NEWMAR CORPORATION WARRANTY DEPARTMENT

TSB05-170-003A

TECHNICAL SERVICE BULLETIN

SUBJECT: Engine Oil Leak – Cummins C8.3, ISC, ISL, ISM

FIG. 4-1

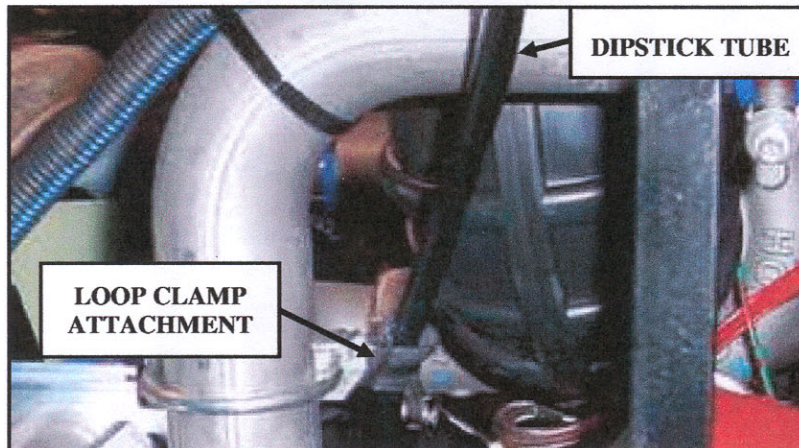
4. To prevent contact with the turbo or any other heat source, secure dipstick tube with the loop clamp provided to an appropriate location as shown in FIG. 4-1, FIG. 4-2, or FIG. 5-1.

Note: Plastic tube must be a minimum of 2.0 inches from the turbo unit or any heat source (i.e. turbocharger, exhaust piping, hot water piping, etc.)

FIG. 5-1

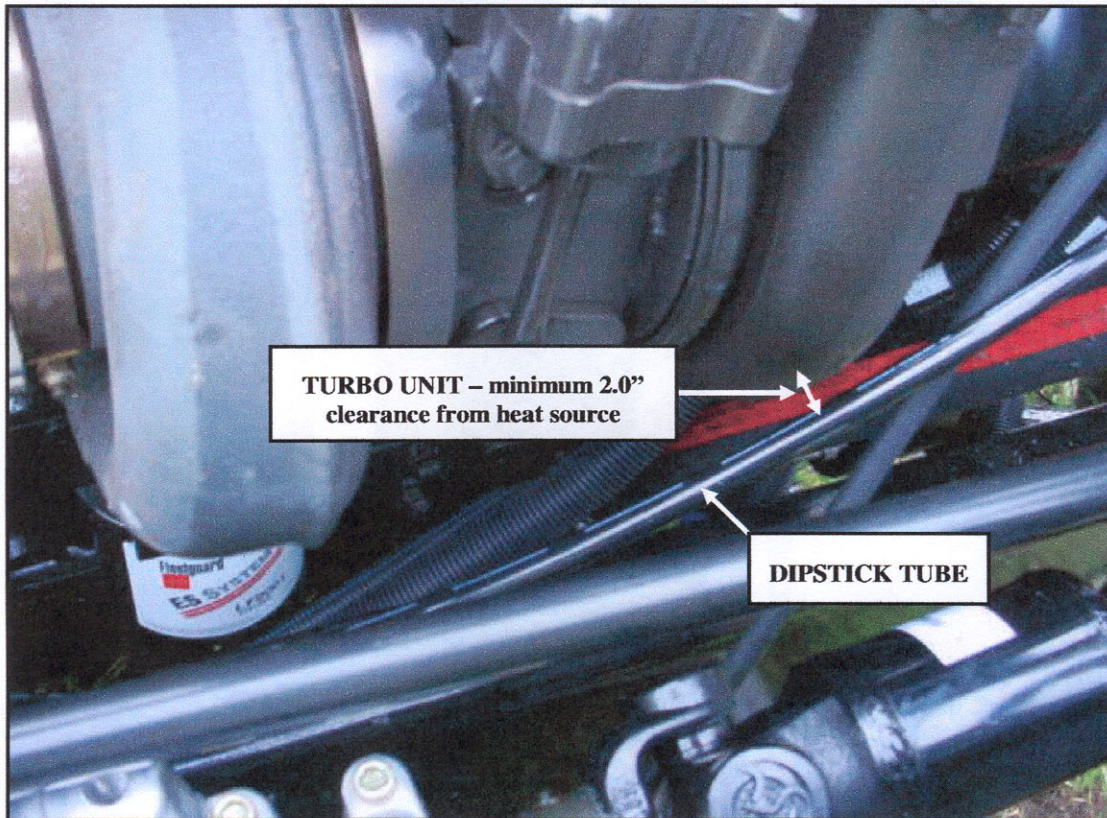
Note: Care must be taken with new tube installation and routing to not to kink the plastic tube, as this will cause resistance when inserting and/or removing the dipstick.
